# Gene Snyder Freeway (I-265) Interchanges (US 60 and I-64)

**VALUE ENGINEERING STUDY**  
*for*  
Kentucky Transportation Cabinet

Study Date: June 10-14, 2002

**Final Report**

SKETCH OF ORIGINAL DESIGN

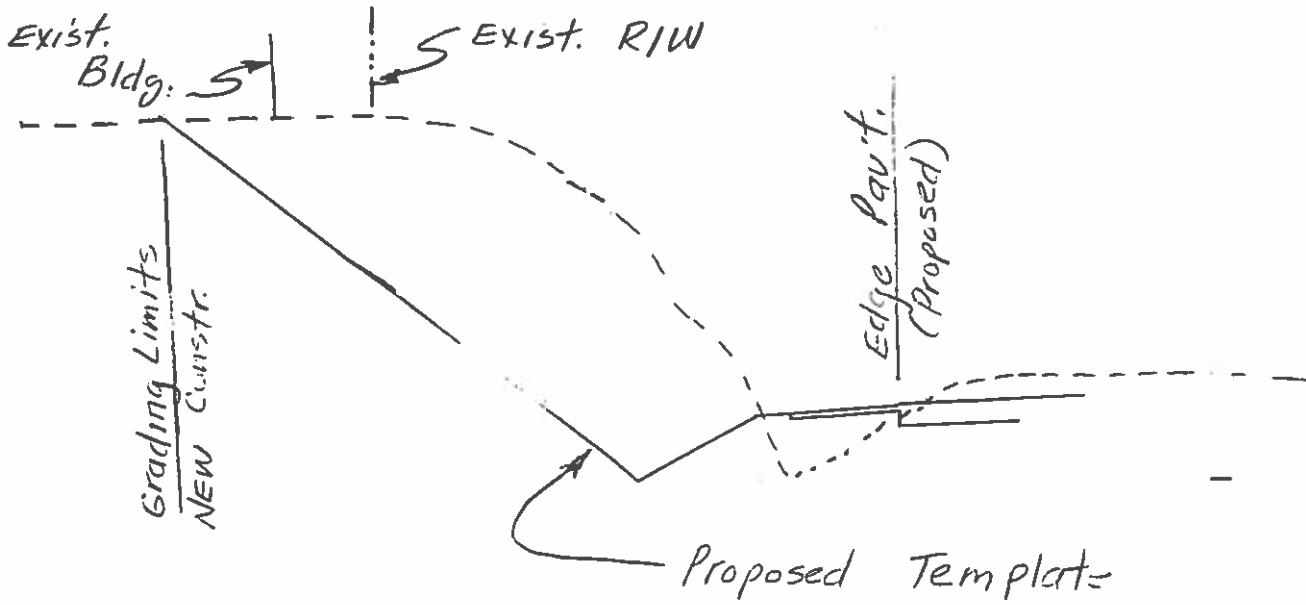
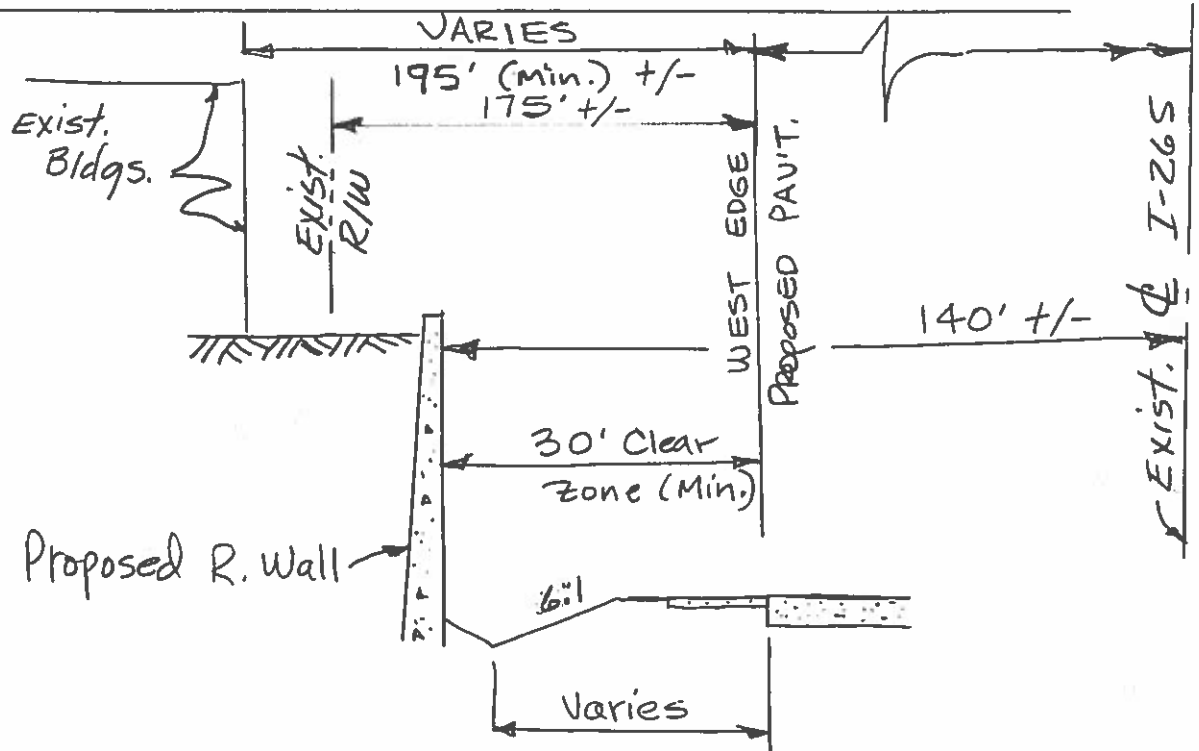
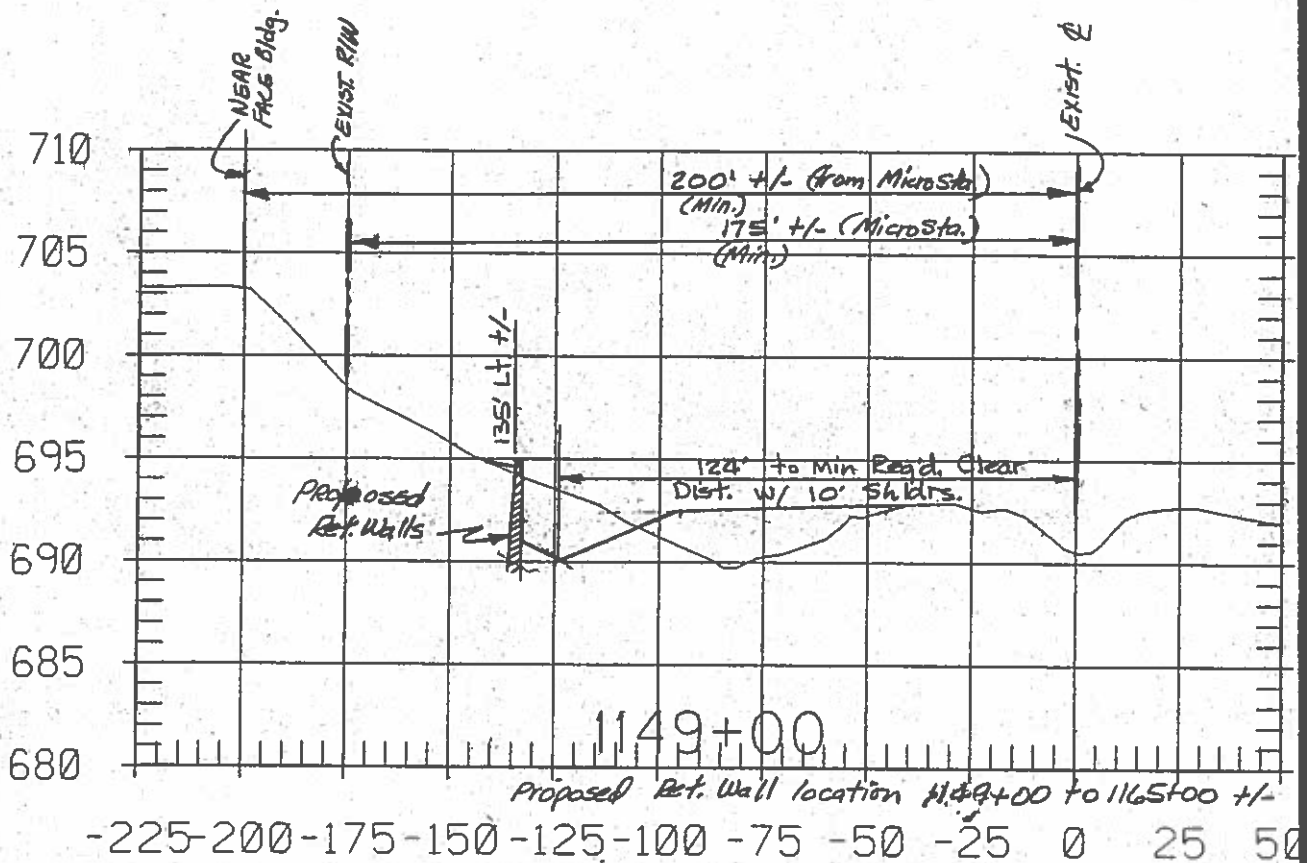
Construct retaining walls to reduce the amount of right of way needed and avoid the acquisition of the business properties.

The retaining wall would perform the same function of the slope at a reduced cost while obtaining the benefits listed above. The issue of aesthetics is a public perception and preference for slopes, however, the retaining wall would not be unsightly given the location of the existing businesses.

Construction of retaining walls may warrant consideration to reduce impacts to adjacent properties in the vicinity of the I-64 / I-265 interchange as well. In particular, the following areas could be considered for detailed examination.

The north side of I-64 between Stations 465+00 and 490+00. Adjacent residential development would be impacted as currently illustrated. Cost to acquire ROW may justify wall construction or use of steeper slopes if feasible.

Steeper slopes may be considered at several locations along both sides of I-265 between Taylorsville Rd. and I-64. Existing slopes are steeper than 6:1 in most locations.
